Service Bulletin

Bulletin No.: 06-06-04-003D

Subject: Service Engine Soon (SES) Light Illuminated, Multiple Powertrain Control Module (PCM) Diagnostic Trouble Code (DTC) P1404 and/or P0404 (Install EGR Valve Kit and Reprogram PCM)

Models: 2005-2006 Buick Rendezvous Built Prior to December 5, 2005
2005-2006 Buick Terraza Built Prior to January 11, 2006
2005-2006 Chevrolet Uplander Built Prior to January 11, 2006
2005-2006 Pontiac Montana SV6 Built Prior to January 11, 2006
2005-2006 Saturn Relay Built Prior to January 11, 2006
with 3.5L V6 Engine (VIN L – RPO LX9)

EGR Valve Identification

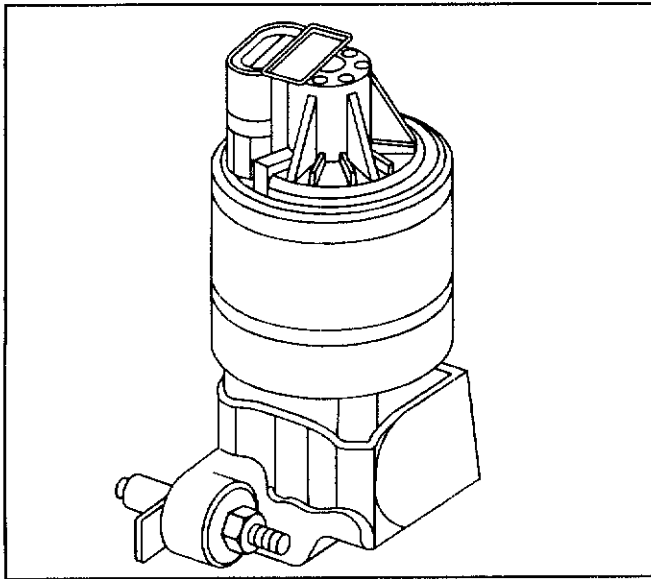
Important: This EGR valve kit is used to convert a Delphi EGR valve equipped LX9 engine used in the Chevrolet Uplander, Pontiac Montana SV6, Buick Rendezvous, Buick Terraza and Saturn Relay to a Siemens valve. This kit contains all the necessary parts for conversion. The Powertrain Control Module (PCM) calibration must be updated for a Siemens EGR valve to work correctly. Failure to install an updated calibration when using this conversion kit may cause PCM diagnostic codes to set, resulting in a Service Engine Soon indicator lamp to illuminate.

Siemens EGR valves have a horizontal electrical connector. Delphi EGR valves have a vertical electrical connector. If a Siemens valve is already installed, it is not necessary to install this kit. Individual components are serviced.
